RECALL NOTIFICATION

RC033502, Reinforcement plate to be added to the rear bolts used to attach seat base through floor into chassis/floor steel frame.

ARBOC Print of ARBOC Part# 1305174 2 x 2 x 1/4 Backer Plate with .531 Hole.

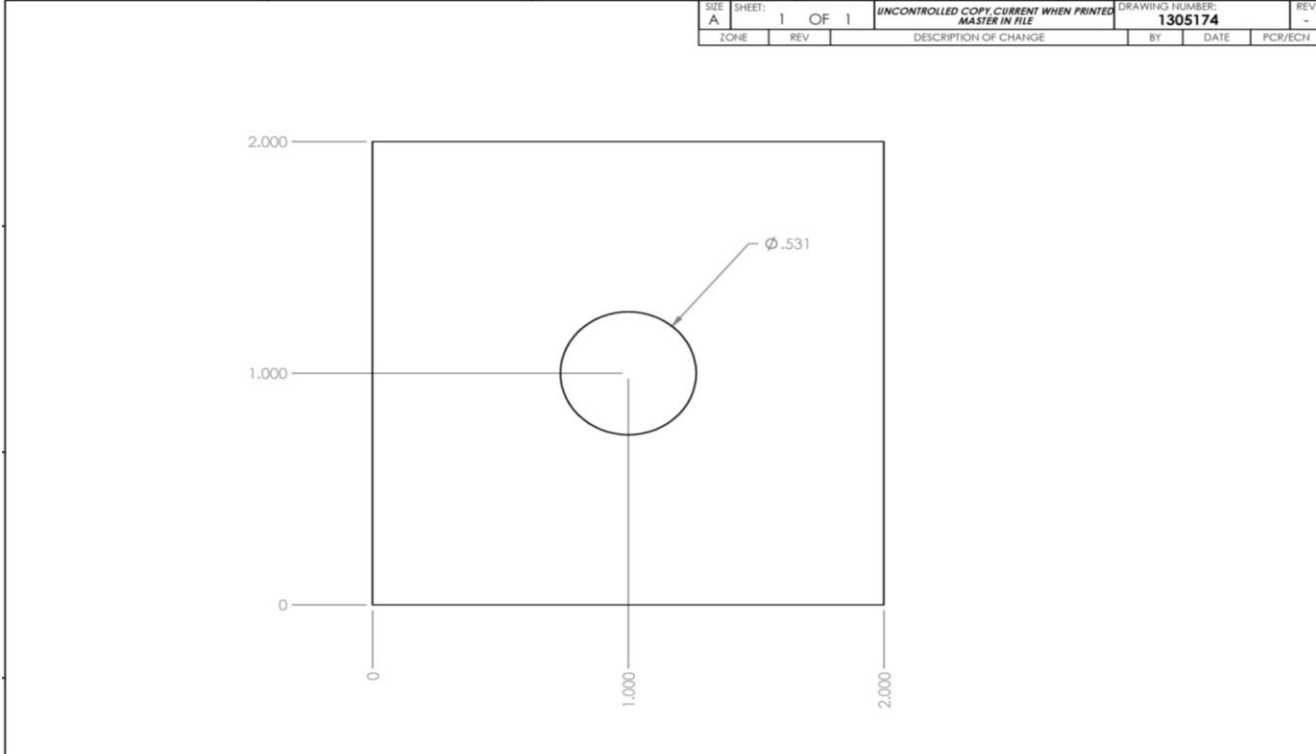
Corrective Action: Add a reinforcement plate (ARBOC Part# 1305174) to rear seat base attachment location. In wheel well locations use reinforcement plate with the drill hole shifted to one side (ARBOC Part# 1305959).

- Step 4: Exterior of bus, under the vehicle, install 1/4" steel reinforcement plate (ARBOC Part# 1305174), One (1) 1/2" Hardened Flat Washer (ARBOC Part# 1188440) and 1/2-13 Flange Crown Lock Nut (ARBOC Part# 465470) to bolt.

Reference view of how seat base attachment look like, From under the bus.

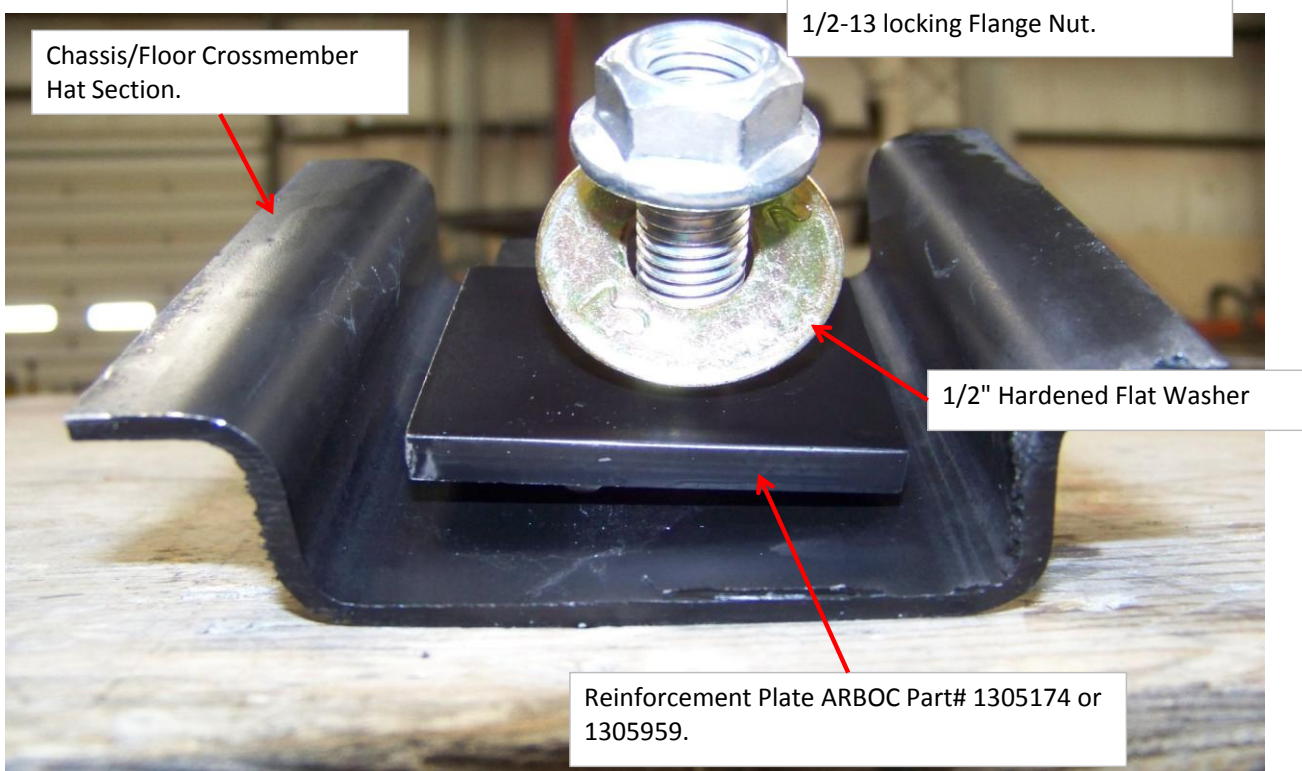
Condition: Reinforcement plates missing on the rear bolts used to attach the seat base through the floor.

Torque Requirement is 60 ft/lb (-0,+5)
